**AGENDA
PLANNING COMMISSION**

Thursday, May 07, 2020

1. [Hillside Development Permit 14-02 \(HDP 14-02\) and Conditional Use Permit 14-08 \(CUP 14-08\); to allow construction of a new single family residence with an attached two-car garage for a total of 4,502 square feet at 9 Nathaniel Terrace, Lot 5 of Tract 54016, in the Stonegate development area](#)

2. [Modification to Administrative Hillside Development Permit 17-02: A request to modify the previously approved plans and elevations of the primary residence at 751 Oak Crest Drive](#)

BUILDING FOOTPRINT COMPARISON

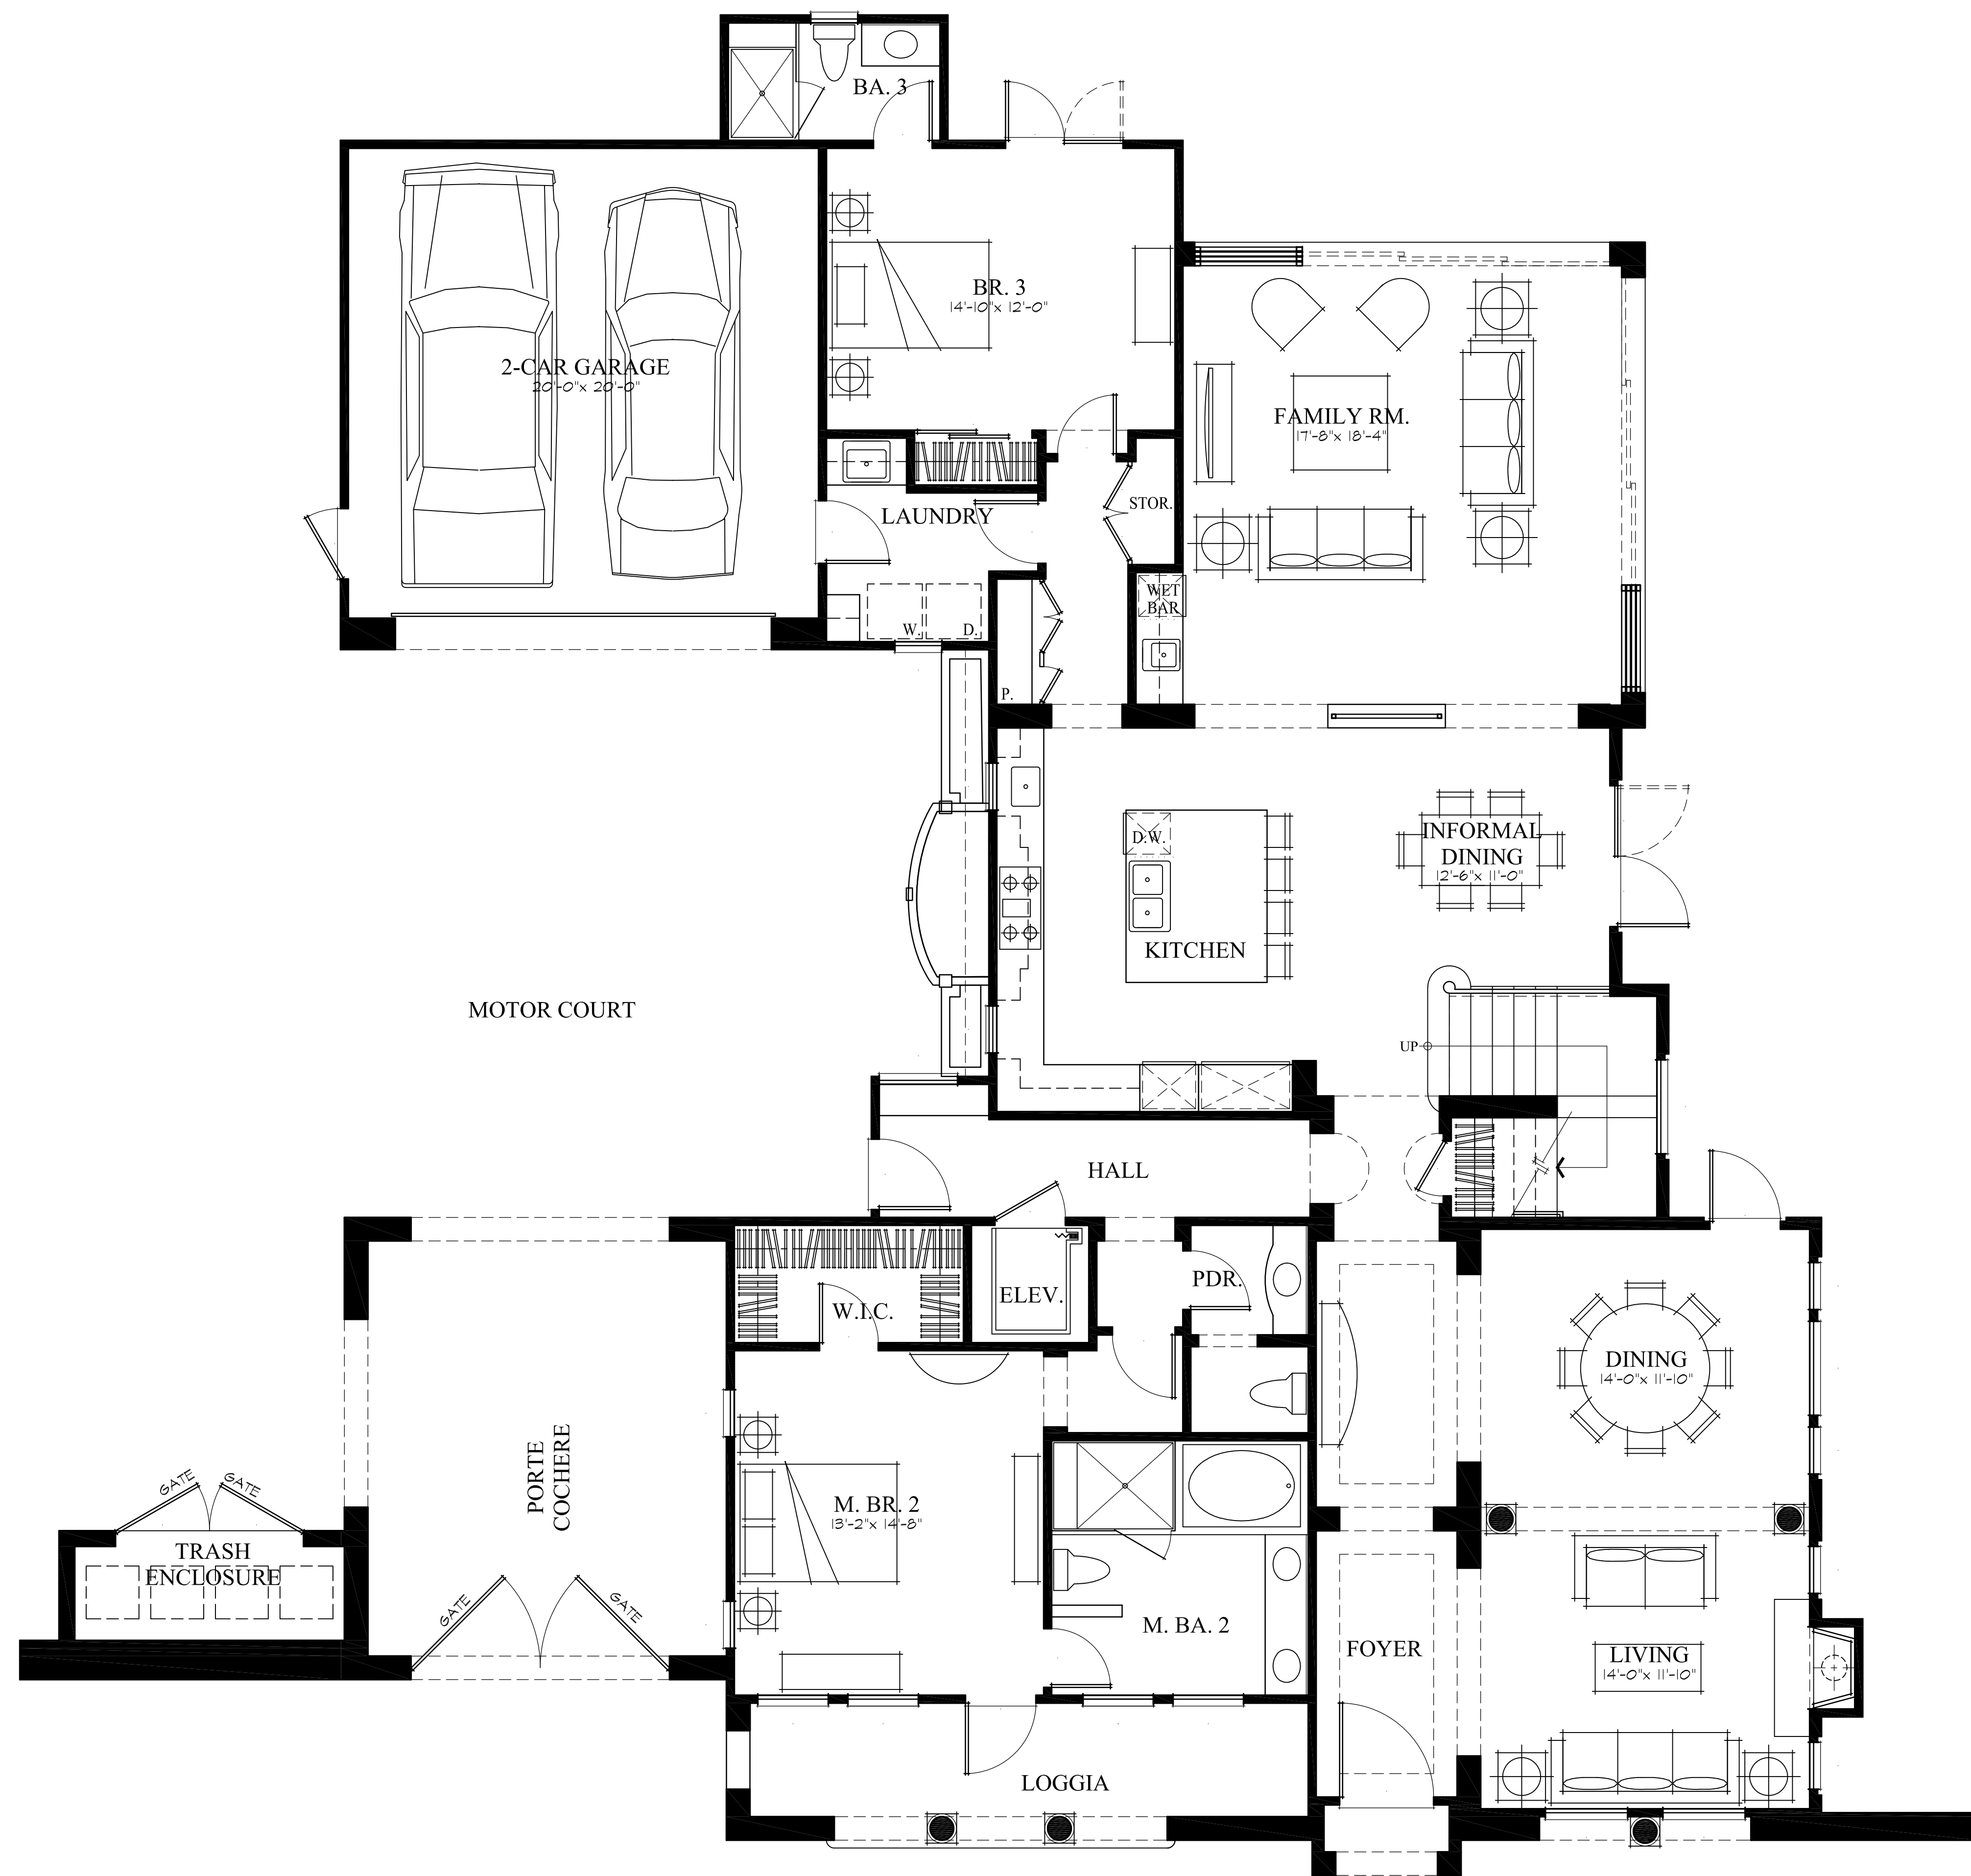
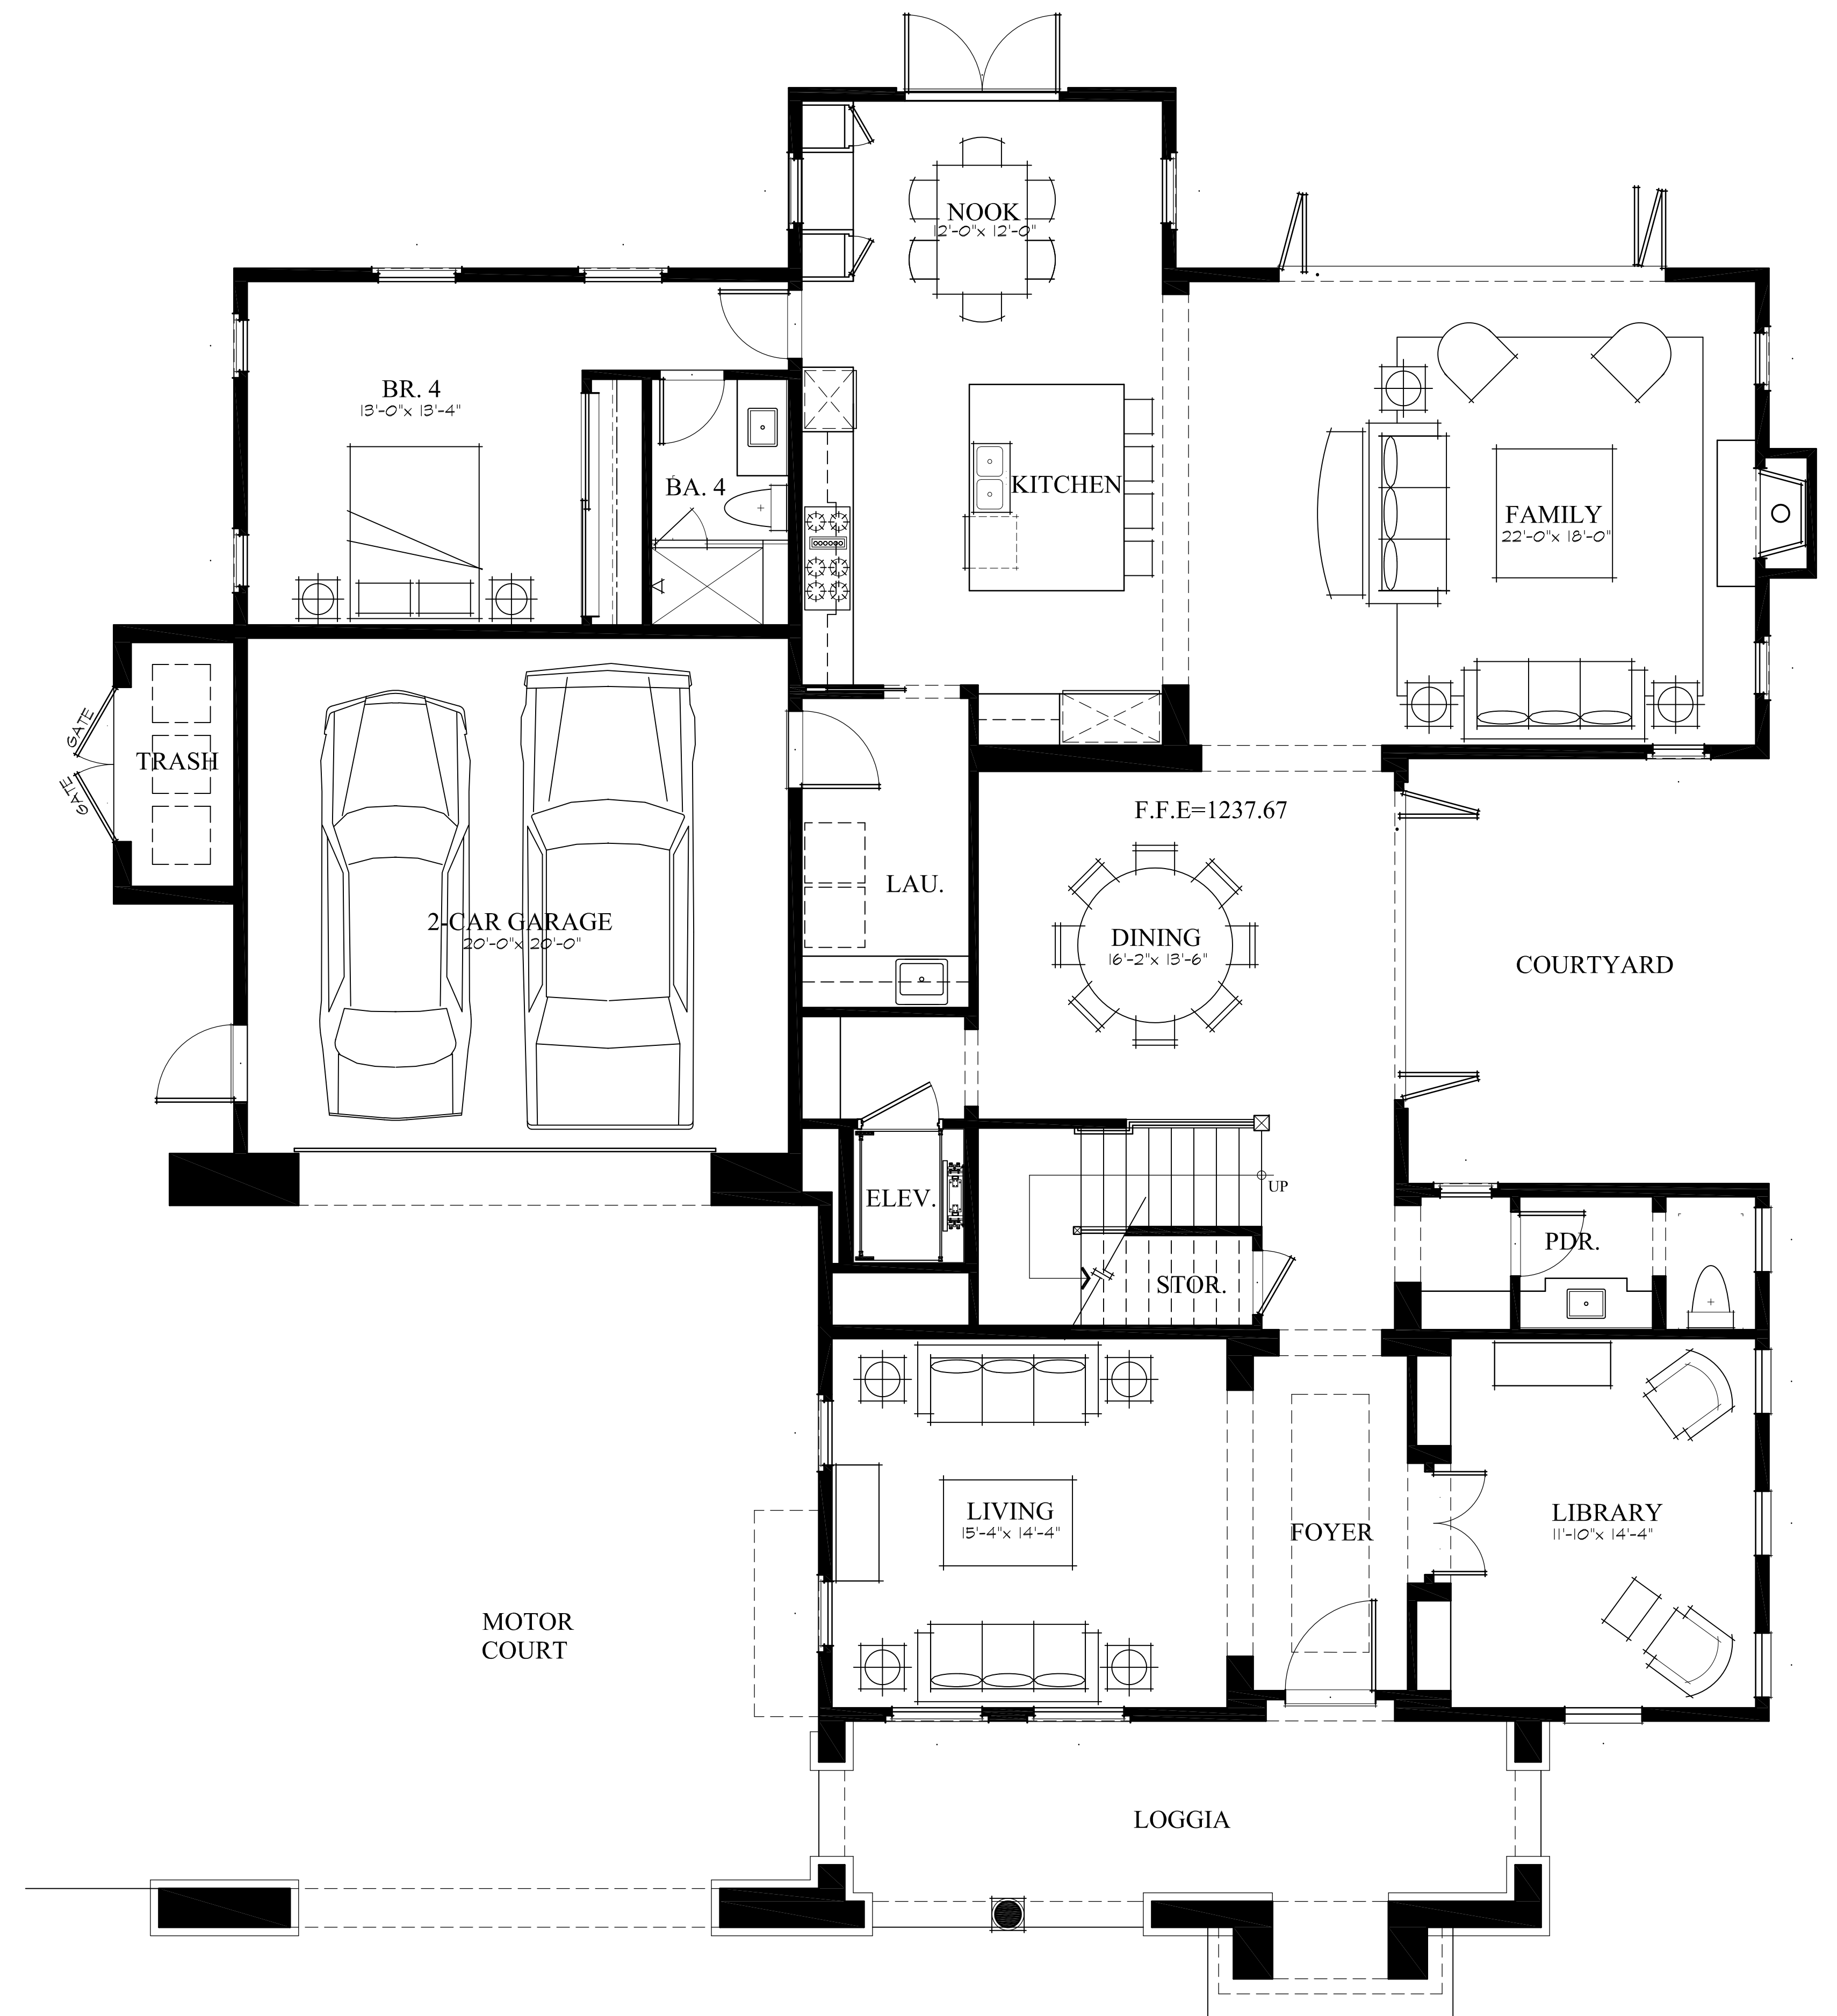
Commission Comment #1: Study the orientation of the massing by placing the courtyard to the south toward the views.

Architect's Response: Building footprint is revised to become more compact by eliminating the porte cochère, enlarged the rear yard, increased the south side yard setback by 4'-10", and introduce a south facing courtyard that faces the views as an extension to the dining room.

- 1) Revised footprint is more compact, smaller structure footprint of 3,060sf, vs. previous structure footprint of 3,180sf, reduction of 120sf.
- 2) Port cochere element eliminated in re-design.
- 3) Increased rear yard area.
- 4) Increased south yard setback by additional 4'-10"
- 5) Courtyard provided at south yard per recommendation from commissioner.
- 6) Building mass significantly reduced at the southwestern corner.
